Toms Gully Underground Project EIS Supplement

Appendix M – NT EPA Correspondence on Primary Gold's Draft EIS

**RE: PRIMARY GOLD LIMITED - TOMS GULLY UNDERGROUND PROJECT –
DRAFT ENVIRONMENTAL IMPACT STATEMENT**

NT EPA COMMENTS ON THE DRAFT ENVIRONMENTAL IMPACT STATEMENT

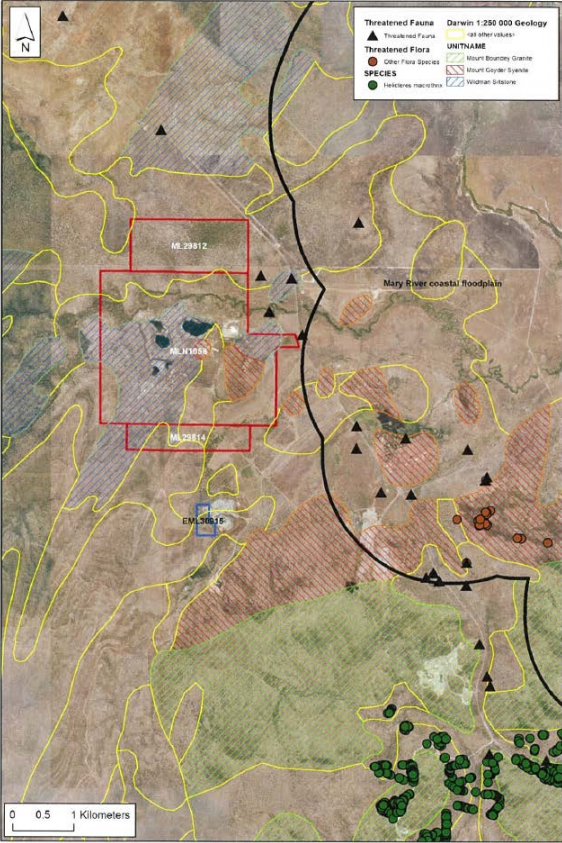
Comments from	Comment
	<p>Mount Goyder Syenite are present within the project area, with the proposed water storage dam lying wholly within a mapped area of Wildman Siltstone (see Figure 1 below).</p> <p>Although there are no records of the species within the tenements, no targeted survey has been undertaken in potentially suitable habitat present within the project area.</p> <p>If <i>H. macrothrix</i> is present within the tenement, the construction of above-ground infrastructure has the potential to represent a risk to the local population as a result of reduction in area of occupancy, fragmentation and impacts upon habitat quality. The proponent should determine the presence or absence of the species on the tenement by targeted survey. If present, assessment of the potential risks to this species associated with all aspects of the proposal (including direct, off-site and indirect impacts) should be undertaken. Appropriate risk minimisation / mitigation measures should be described.</p> <p>Comprehensive details have been provided outlining site rehabilitation and closure associated with the Tom's Gully Mine operations. Although these cover a range of possible closure scenarios, it is anticipated that the measures outlined in the EIS should allow effective revegetation of the mine site if implemented in accordance with best practice industry standards.</p> <p>In addition, it is recommended that revegetation goals aim to re-establish vegetation communities characteristic of the pre-clearing vegetation mosaic of the local area. This would increase the likelihood of successful revegetation outcomes and integration of the disturbed areas into the surrounding landscape.</p> <ul style="list-style-type: none"> • The draft EIS references the Erosion and Sediment Control guidelines (NRETAS, 2006) in Section 2.6.3 and makes reference to developing an Erosion and Sediment Control Plan (ESCP). However, the EIS does not describe what erosion and sediment control (ESC) strategies will be undertaken during the life of the mine. <p>To service environmental management objectives associated with the use and land disturbing activities, the Department recommends that an ESCP be developed, and be cross-referenced with the Mine Closure Plan. The ESCP will support environmental management of land disturbing activities by facilitating preparation of work costs and schedules, provide direction for site management and personnel responsible for implementing ESC and rehabilitation measures, and assist monitoring activity.</p>

Comments from	Comment
	<p>used to run the model.</p> <p>It is understood that the new dam height would be 12 to 14m, which may require a permit under the <i>Water Act</i>.</p>  <p>Figure 1: Biodiversity values in the vicinity of Tom's Gully Mine, MLN 1058, ML 29812 and ML29814 on Old Mount Bunday Station (NT Portion 4937). Background imagery from Google Earth.</p>
